# Service Instruction

(a) No.:	SI05
(b) Revision / Date	A/September 2013
(b)Title:	A-530 Rigging to CQ2015 Burner Frame
(c)Description:	Information additional to HABFM i10
(d)Applicability:	EASA.BA.013, A-530
(e)Effectivity:	All C/N

View from basket

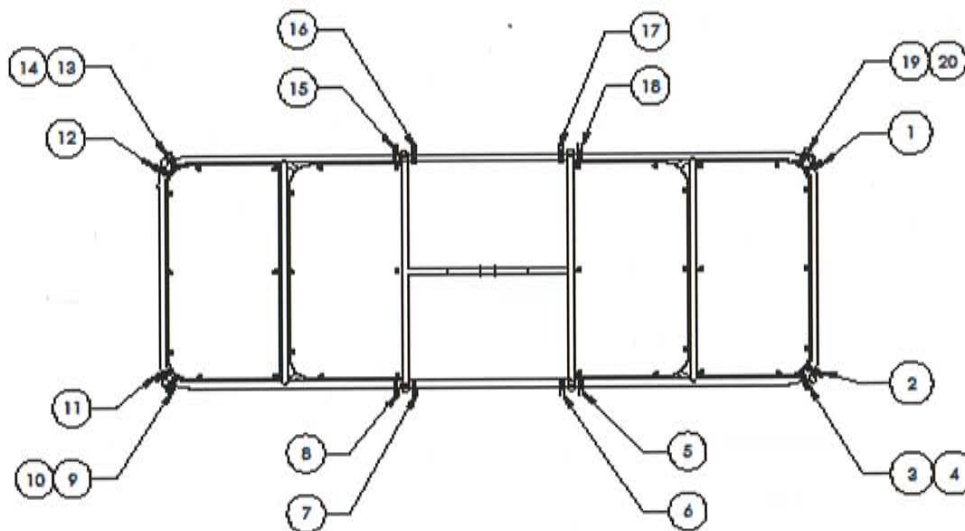
## 2. Accomplishment Instructions
